World Forum for Harmonization of Vehicle Regulations**Working Party on Passive Safety****Sixty-ninth session**

UN Regulation No. 129 (Enhanced Child Restraint Systems)**Proposal for draft Supplement 8 to the 01 series of amendments to Regulation No. 129 (Enhanced Child Restraint Systems)****Submitted by the expert from Spain***

The text reproduced below was prepared by the expert from Spain on behalf of the Technical Services Group (TSG) on UN Regulation No. 129. The modifications to the current text of the UN Regulation are marked in bold for new or strikethrough for deleted characters.

Figure 3
Minimum distance for lateral impact

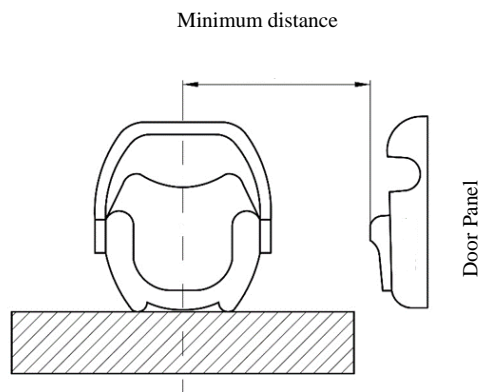
For each test, the initial position of the side impact door panel relative to the bench shall be adjusted according to the minimum distance between the vehicle's door panel and the centre of the seating position as shown in figure 3.
